FLIGHT DESIGN <small>LIFTAIR®</small>	<h2>Service Bulletin</h2>
Flight Design general aviation GmbH Am Flugplatz 3, D-99820 Hørselberg Hainich, Airfield Eisenach-Kindel Web: www.flightdesign.com ; Phone: +49 36920 7530-10 E-mail: airworthiness@flightdesign.com	SB-ASTM-CTLS-16, Revision 00 Date of Initial Publication: 22-Nov-2019 Publication Date of this Revision: 22-Nov-2019

Installation of Starter Solenoid on CTLS with Large SLA Battery SB-ASTM-CTLS-16

incorrect installation of starter solenoid, collision with throttle cable housing

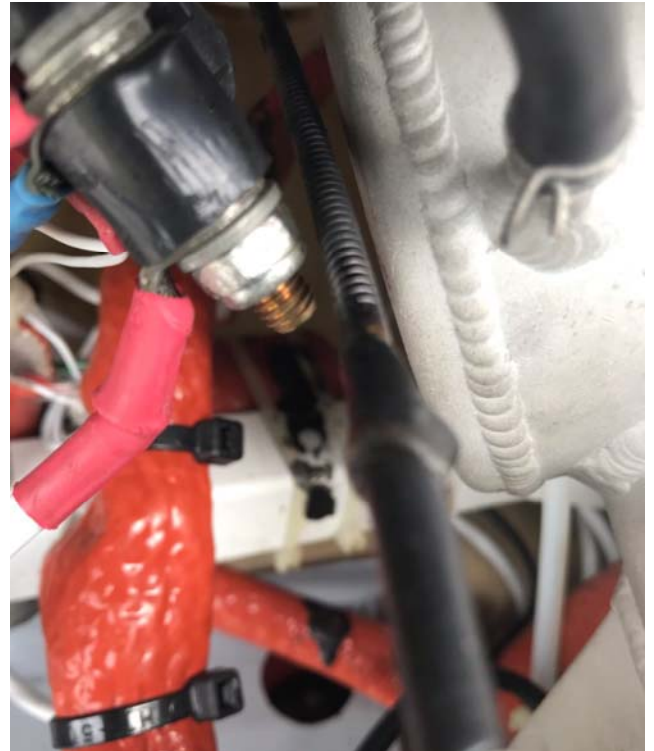
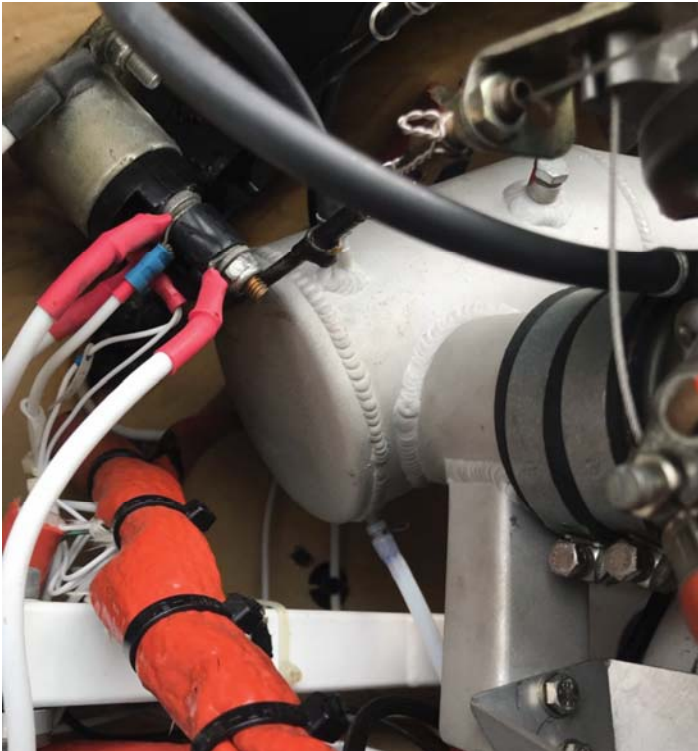
Some CTLS are equipped with a larger sealed lead acid battery. This requires a different location of the starter solenoid. Under certain unfavorable combination of tolerances, contact of the starter solenoid may contact the throttle cable housing, which in return gets worn through over time. An unprotected electric short circuit may be the result.

The starter solenoid must be installed in a correct position. This may be accomplished either by using existing tolerances or by help of an adaptor plate.

correct installation of starter solenoid

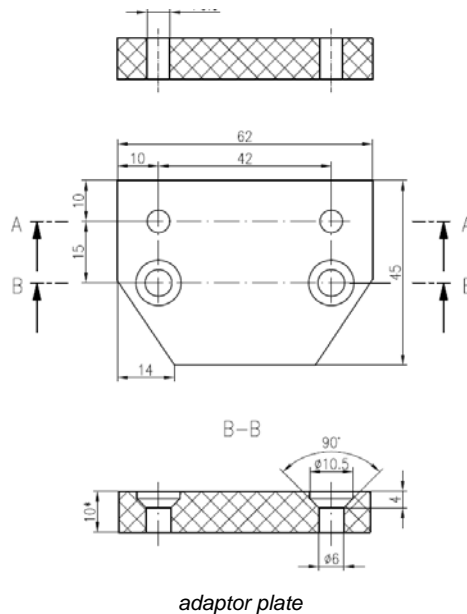
- Open the cowling
- Identify the throttle cable housing of the right carburetor
- Identify the starter solenoid
- Determine the distance between Bowden wire and contacts of the solenoid
- Distance should be at least 15mm-1/2 inch (a finger should fit in between)

- Disconnect battery
- Detach solenoid from firewall
- Turn solenoid by 180 degrees (need to detach starter wiring temporarily)
- If needed prepare an adaptor plate to relocate the solenoid for correct distance to throttle cable housing.
- Properly attach solenoid and starter wiring.
- Reconnect battery.
- Close cowling.
